From: Ian Reynolds <ian.reynolds@tungstenwest.com>
Sent: 24 November 2023 15:17
To: Walker, Jake
Cc: Argent, Rob; Beamish, Louise; emily; Brian Jarvis; Neil Gawthorpe
Subject: Response to Environment Agency Questions 23 November 2023
Attachments: 70108756 Three Months Collated Data.xlsx; Table 6-3 of the NIAv3.docx

Environment Agency Question One:

Tungsten West Response to Question One:

The following screen shot from the excel file shows all boundary locations provided as per tab ‘Chart_All operational Data’.

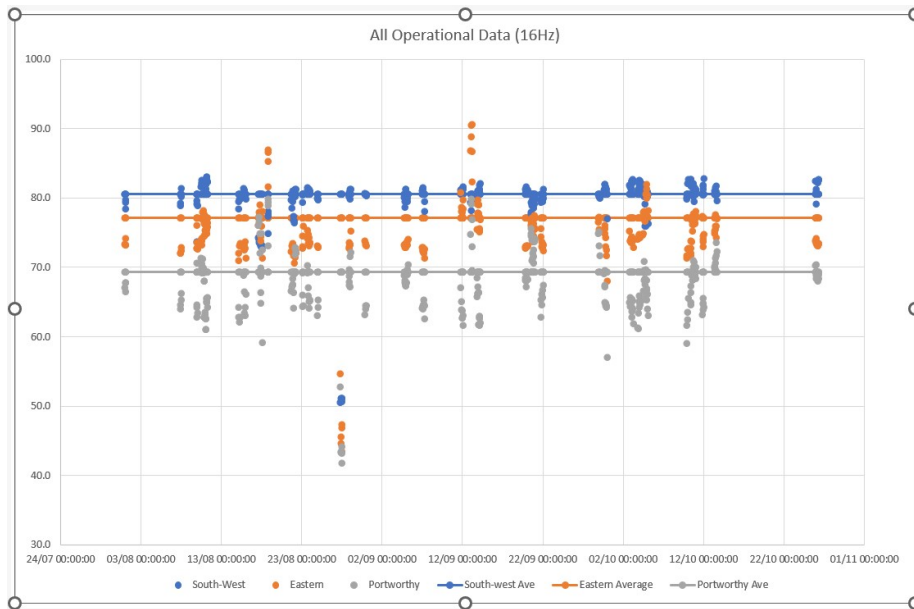
We require a comparison of all available low frequency noise monitoring data from the Wolf Minerals' operation, against the predicted levels for Wolf modelled in the LFN Noise Impact Assessment. Your comparison should consider wind direction, and the observation that an underprediction of 6.4dB was observed for downwind receptors in the NIA Table 9-2.

This data includes an eastern boundary monitoring position which is regularly down wind of the site. It is noted that the predicted levels in Table 6-3 and Figure 6-6 are based on neutral wind conditions, and that an underprediction of 6.4dB was observed for downwind receptors in the NIA Table 9-2.

The attached spreadsheet (70108756 Three Months Collated Data) includes the 12.5Hz, 16Hz and 20Hz data and the weather data for the three-month monitoring period from August to October 2017, as shared by the Environment Agency on 22 November 2023. These data are included in the tab "All Data". Also in this tab is information on whether all Wolf Minerals' screens were operating at the time of noise measurements (see column T).

Data where all screens were running have been used in our analysis and the remaining data, gathered when limited/no screens were operating, have been discarded. The data carried forward for our analysis are shown in the tab "Operational Data". These data are plotted in the four graphs in the spreadsheet – one for each of the three monitoring locations and the fourth showing operational data at all three locations. The solid lines on each of the

graphs represents the logarithmic average of the measured operational levels at each location (see tab “Averages” for the workings).

From the data provided it appears that the ‘South-West’ boundary data are lower than expected, possibly due to monitoring equipment issues; the values at this location had been expected to be significantly higher. The lack of any reasonable data spread tends to align with this view.

We have not derived a range to represent the baseline noise level for the Wolf Minerals operation as this would introduce yet more conservative assumptions into the assessment, potentially (and falsely) highlighting the need for additional mitigation. It is possible that some of the ‘lower’ readings have occurred with some screens off or unloaded which would require the TW modelled data to also be adjusted to reflect unloaded (lower screen efficiency) or screens not running. All TW modelled outputs assume all screens operating at a conservative screen efficiency at all times.
